**REMARKS**

I. THE AMENDMENTS TO THE DRAWINGS

Fig. 3

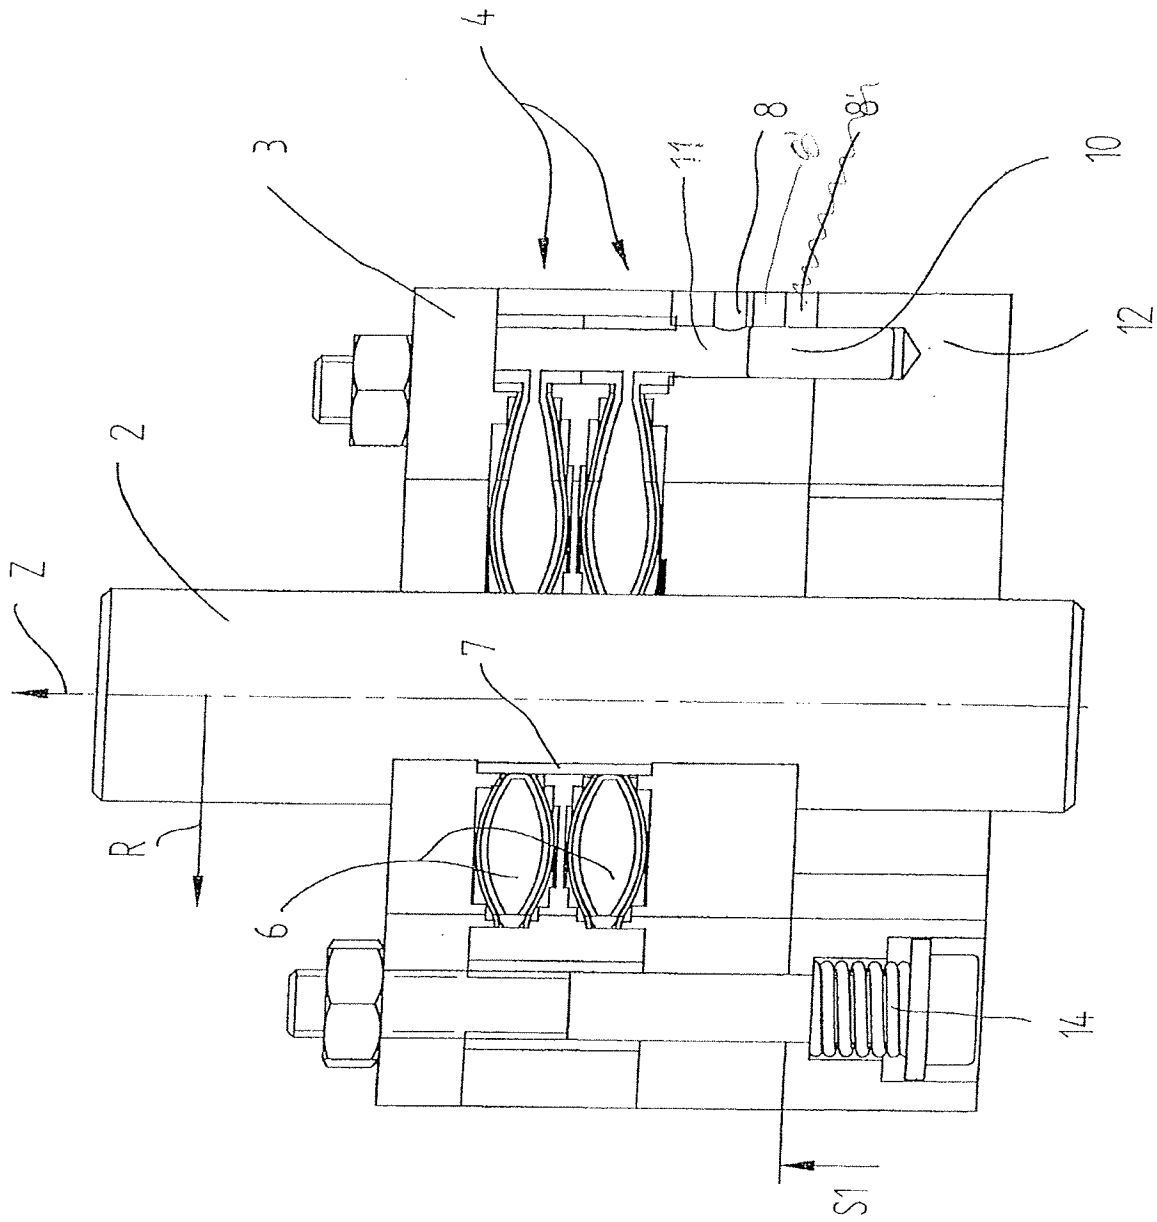
Enclosed with this response is a replacement drawing sheet for drawing sheet 3 and a replacement drawing sheet for drawing sheet 4 in compliance with 37 C.F.R. §1.121(d) together with a marked-up version of each replacement drawing sheet in accordance with 37 C.F.R. §1.121(d)(1). The replacement drawing sheets each provide the correct lead line from reference numeral 8' to the medium recycling line.
